Product Change Notification

113233 - 00

Change Notification #: 113233 - 00
Change Title: Intel® Server System R1208GZ4GS9,
R1208GL4DS and R1208GZ4GC
PCN113233-00, Product Design
Add a Mylar, Plastic Block and
750W Common Redundant Power Supply
Date of Publication: September 4, 2014

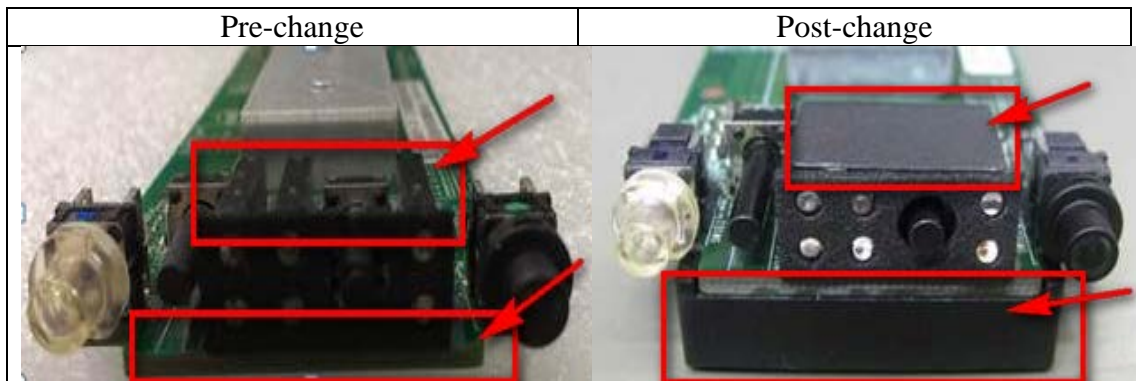
Intel is implementing the following change on the Intel® Server System R1208GL4DS and R1208GZ4GC:

Add a mylar on the top of the front panel board and add a plastic block for the front end under the front panel board to hold parts more securely. See the images below:
